CITY OF WESTLAKE

DATE:	3/5/2026
APPLICATION NUMBER:	SPR-2025-01
DESCRIPTION:	Walmart – Grocery and Liquor Retail Store
APPLICANT:	Cotleur & Hearing
OWNER:	Minto PBLH, LLC
REQUEST:	Site Plan Review
LOCATION:	Westlake, FL
STAFF REVIEW:	APPROVED WITH CONDITION(S)

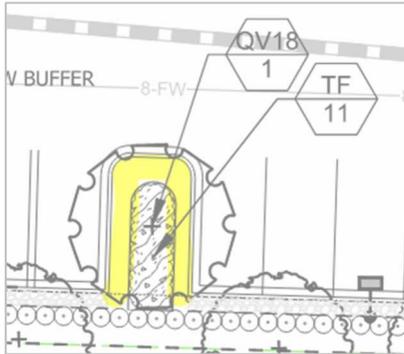
33. Provide a calculation for the proposed pea gravel. Gravel may be used up to a maximum of 10% of the ground coverage.

Applicant Response: Calculations have been provided on the landscape plans.

City Response: Comment satisfied.

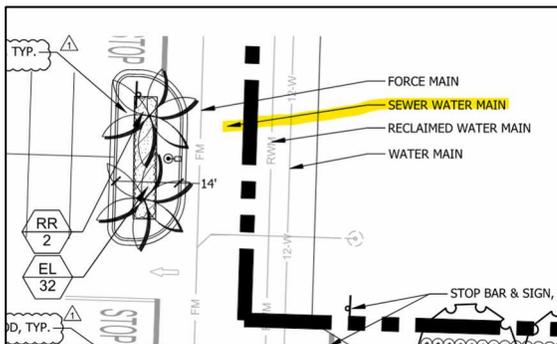
36. Please correct any erroneous labels.

Applicant Response: No response provided.

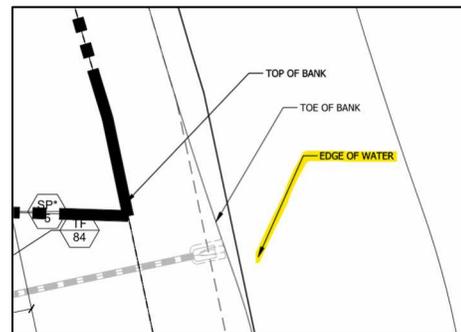
City Response: Partially satisfied. There are still labels not pointing to anything. See below and correct on plans.

Applicant Response: No response provided.

City Response: Comment satisfied.

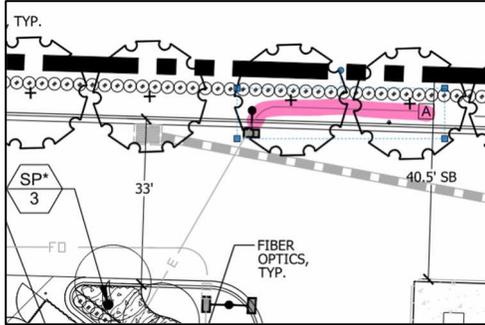
37. Call out this equipment on the north side of the convenience store and ensure there is no conflict with the proposed trees in this area.

Applicant Response: No response provided.

City Response: Comment not addressed.

Applicant Response: Comment has been noted and will be addressed in the final Site Plan review.

City Response: Comment remains and is to be addressed during Landscape Plan review. This level of detail is not required for Site Plan submittal; for Site plan purposes this comment has been addressed.
